BULLETIN #003

CONTRACT NO.: 15-015-CIP	DESIGNER: EMH&T
PROJECT NAME: John Shields Parkway, Phase 2	PROJECT MANAGER: Mandy Bishop, P.E., S.I. - GPD
CONTRACTOR: Nickolas Savko and Sons, Inc.	
DATE: JUNE 14, 2016

EMH&T Revision 4 – Revises changes made to the Columbus Industrial Entrance and Parking Lot Modifications.

JOHN SHIELDS PARKWAY PHASE 2

TRAFFIC CONTROL PLAN
Sta. 674+00 to Sta. 678+50

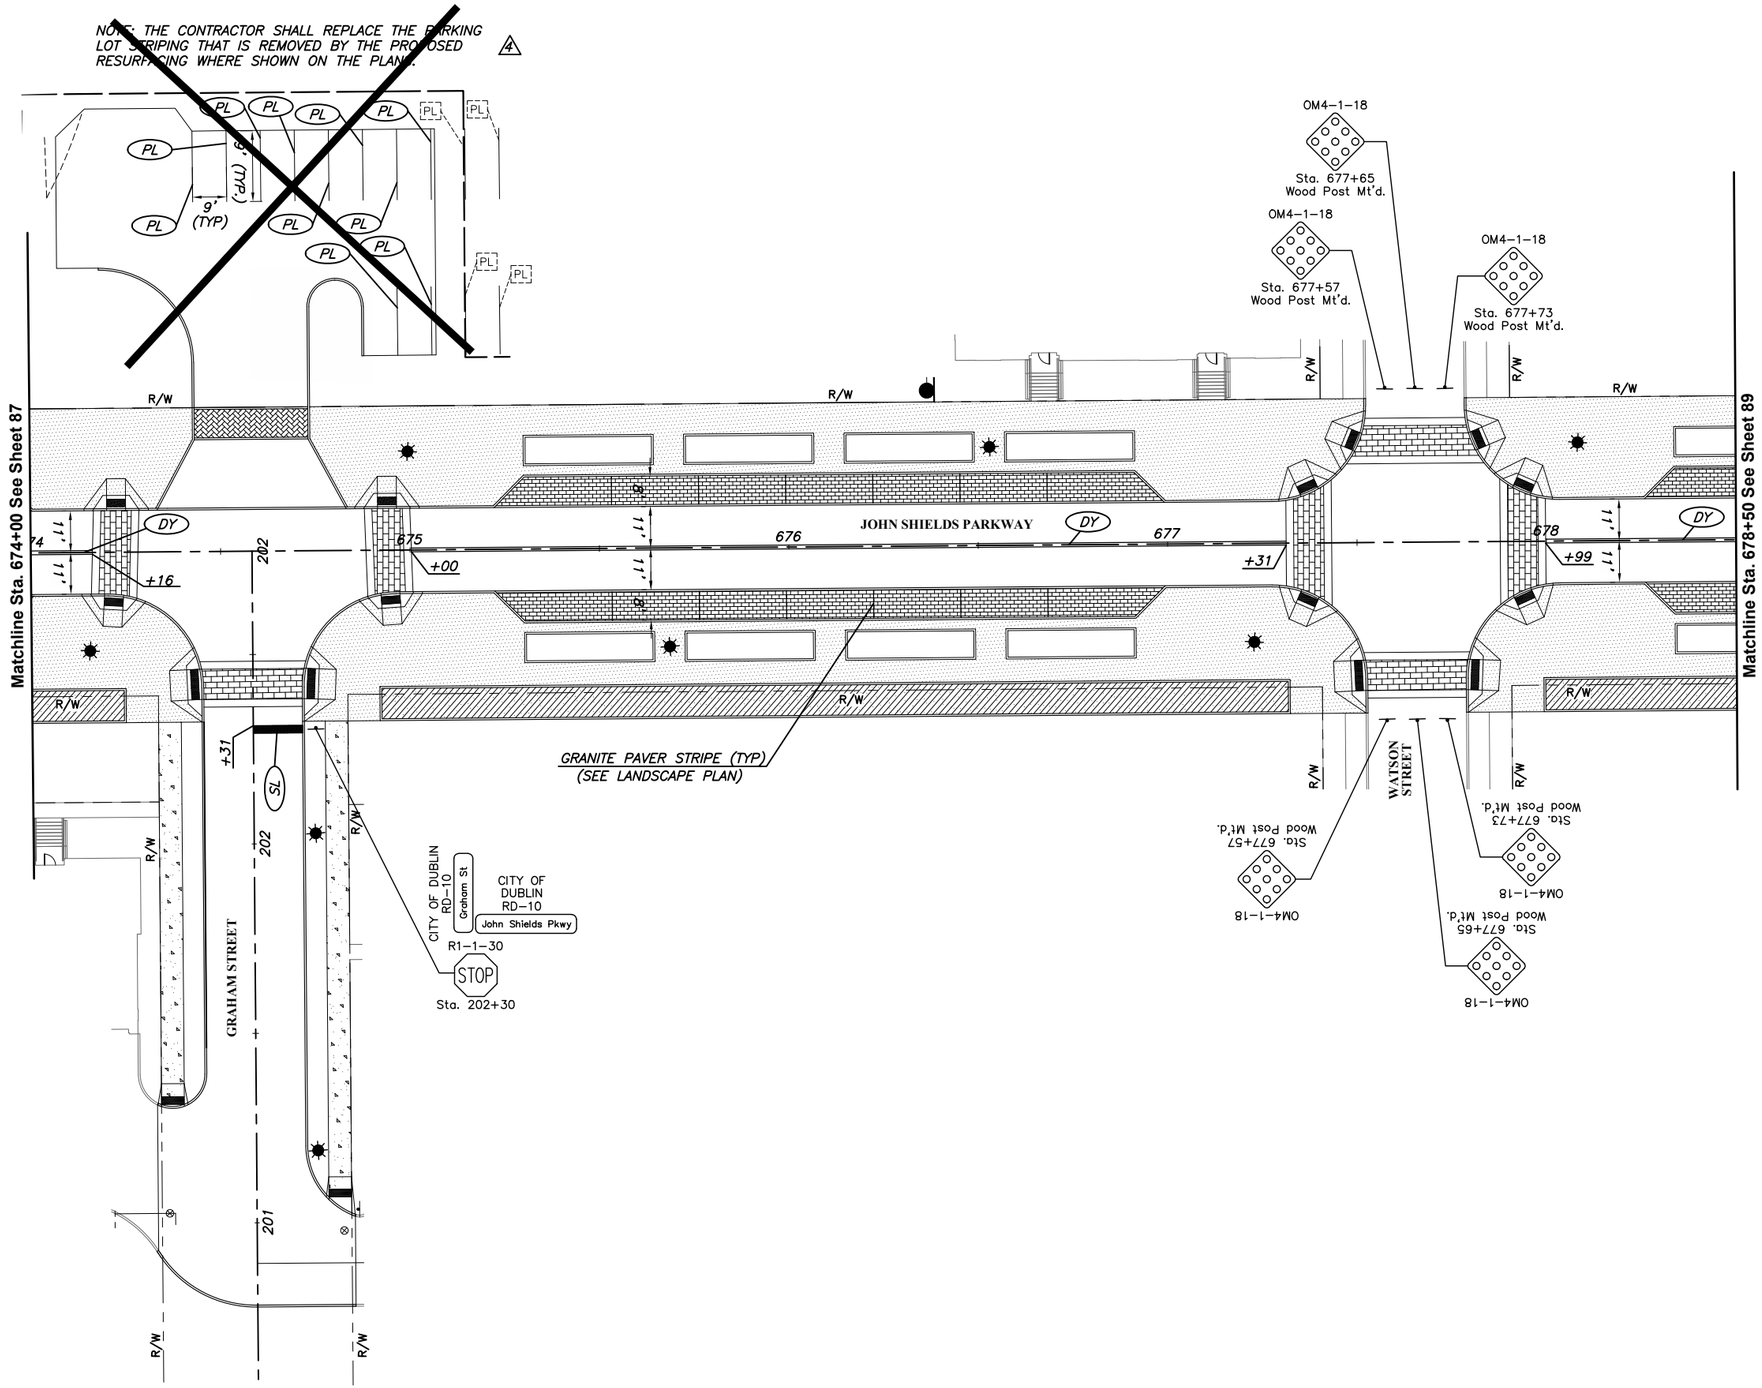
REVISION	DATE	DESCRIPTION
4	6-9-16	Parking Lot Striping Modifications Shown on Sheet 63B
